# MUKLUK SUBDIVISION PHASE 1

### AMENDED PLAT

**SURVEYOR'S AFFIDAVIT**

Alaska State Land Survey 2020-24, Mukluk Subdivision

#### DETAIL A (N.T.S.)

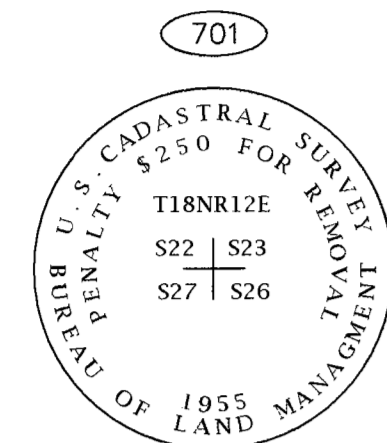
The only change on this Plat, from Plat 2022-27, is correcting the Owner's Certificate and Notary dates and adding a detail for the NW & N1/4 section corners.

The Owner's Certificate signature date and the Notary date for the Certificate have been written down as the same  
date and adding a detail for the NW and N1/4 Section Corners.  
\_\_\_\_\_
